MEMORANDUM

REVIEW TYPE: Mandatory Referral
PROJECT NAME: Bridge Connection to Jesup Blair Park
Montgomery College, Takoma Park Campus Expansion

CASE NUMBER: 01103-M-01

STAFF RECOMMENDATION: APPROVAL WITH COMMENTS

Area Which is the Focus of this Mandatory Referral Review

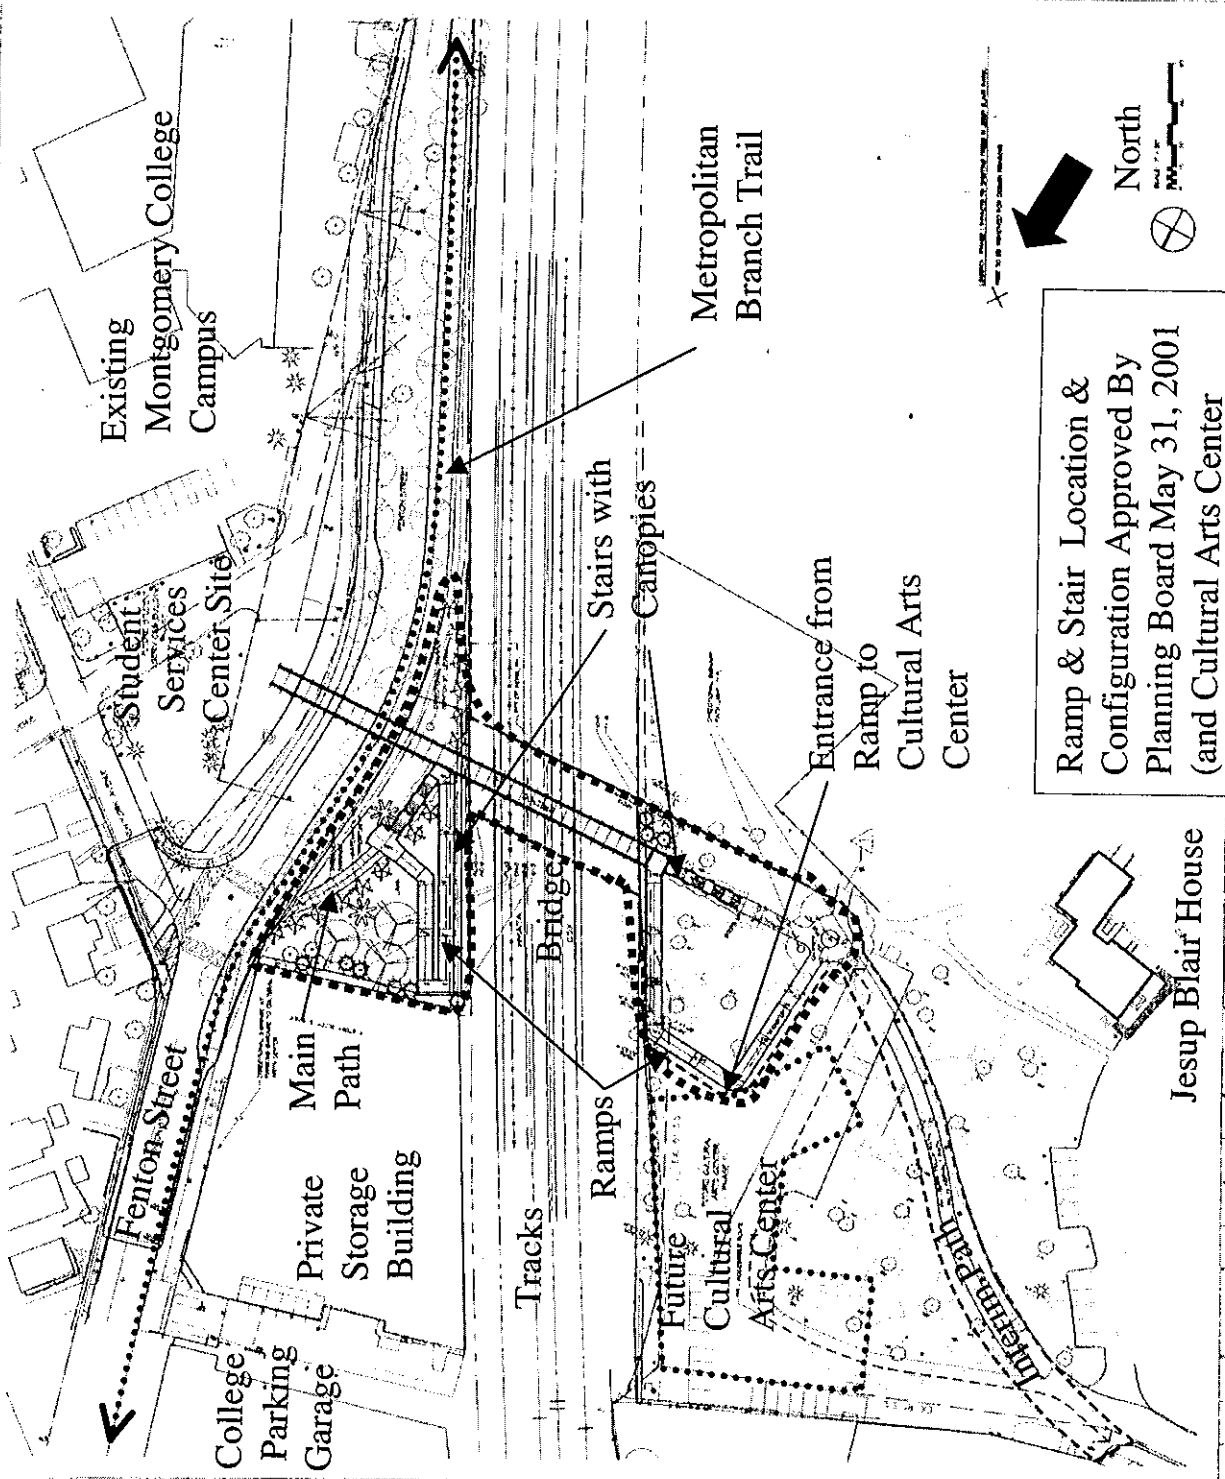
- a. The switchback at the top of the ramp should be eliminated to improve the route for those with bicycles, strollers and wheelchairs, and to turn an otherwise unused corner into passage space. (Page 12.)

- b. The intersection of the ramp path where it joins the main path currently is a T-intersection. This intersection should be rounded so people are not cutting across the corner following the flow of all the traffic. Ramp users should not have to make a sharp turn at the base if that can be avoided. They are the users who would most benefit from a soft flowing turn—they include all the users with bicycles, strollers and wheelchairs. (Page 12.)

- c. The intersection of the path where it meets the Metropolitan Branch Trail should be widened slightly and the corners rounded for the benefit of all users coming from either direction. While this may be difficult to do for those coming to the trail from the south, due to the slope of the path, it should still be considered. (Page 9.)

N Park - Canopies over Stairs

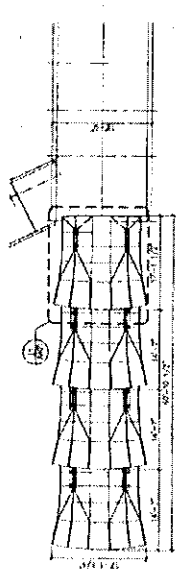
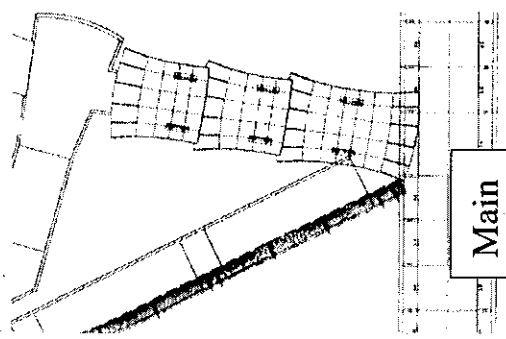
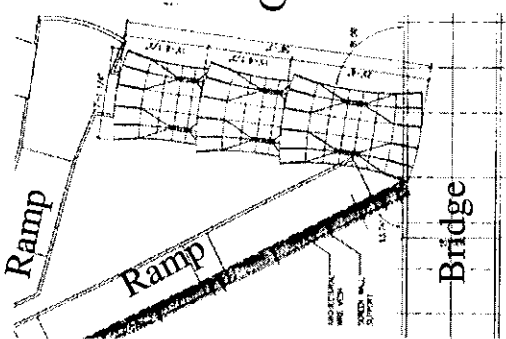
- a. *To minimize the mass of the stair structure in the park, the steps should not be enclosed. If the College determines that a roof is absolutely necessary it should be transparent. Means other than roofing for avoiding costly snow and ice removal should be explored. The steps should be designed to ensure compatibility of the structure with the park setting.*

Another issue pertains to ensuring compatibility if there are design changes that the College wishes to make as the bridge design is finalized. For example, to add to the lightness of the canopies over the stairs and to enhance the structure's compatibility with the Park, the designers created the canopies with a fan-shape with a leading edge that is glass and transparent. The remainder of the canopy is an opaque white both on the skyward side and on the underside visible from the stairs and park. The glass edge is an attractive feature; however, due to budget constraints, the College has explained that it may be removed from the final design. The College is encouraged to keep this feature in the design. However, if it feels that it is important to remove it, this design change could be handled administratively by staff. However, any other significant changes to the bridge should be brought back to the Planning Board for review.

- The sides of the stairways are open.
- The roof over the steps has been changed to canopies which are now light and open, floating in several separate ascending panels that fan out. The leading edge of each panel is transparent glass. The College felt that alternatives to a roof or canopies, such as heating wires in the steps to melt snow and ice, were not long term solutions due to wear over time.

Fenton Street - Stairs & Ramp Joining Bridge

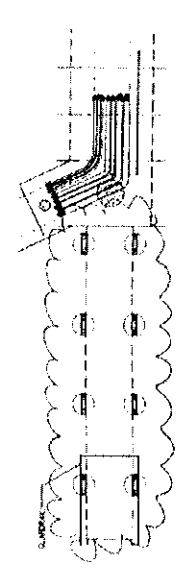
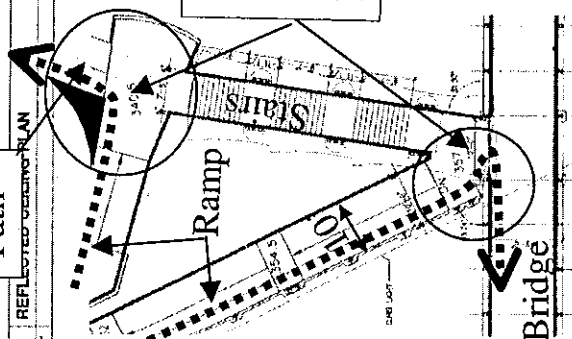
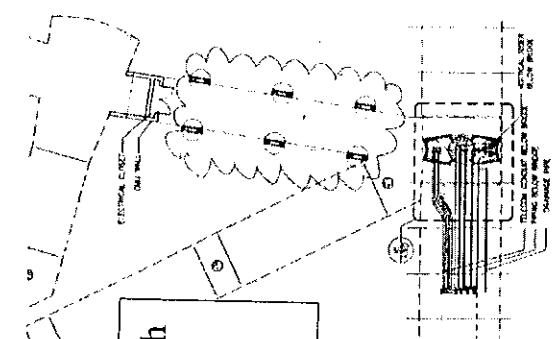
- a. Eliminate the "switchback" at the top of the ramp to improve the route for those with bicycles and wheelchairs.
- b. Ease the intersection of the ramp path as it joins the main path so that ramp users—like stair users—do not need to turn a sharp corner.
- c. Ease the corners where the path meets the Metropolitan Branch Trail and widen if possible.

Flexible Wire Mesh for Fence
along Tracks and for the Panels
of the Guard Rails along the
stairs and the ramps.

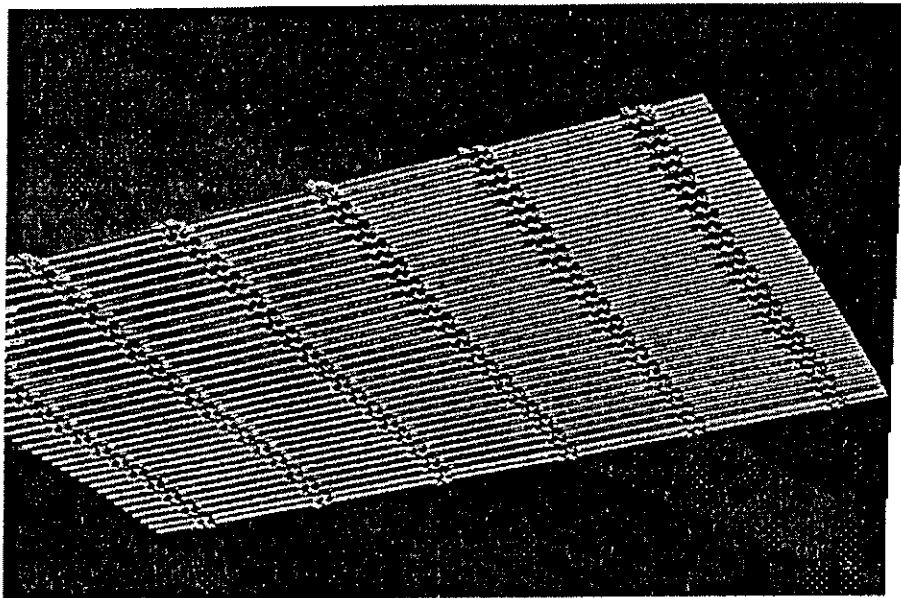
- b. *The wire mesh fence that is required by WMATA/CSX along the ramp adjacent to the railroad tracks should be designed to contribute to the gateway image for both Jesup Blair Park and the Silver Spring CBD. A similar approach should be considered for the ramp from Fenton Street.*

- The structural supports for the steps and the canopies consist primarily of open, light frameworks.
- The fence along the railroad track is a steel mesh. The horizontal slats are made of steel tubes and the vertical elements holding them together are steel fasteners. The mesh is semi-transparent and flexible. It is also used in the railing panels and in the "clerestory" openings for air circulation that run under the eaves of the bridge roof.
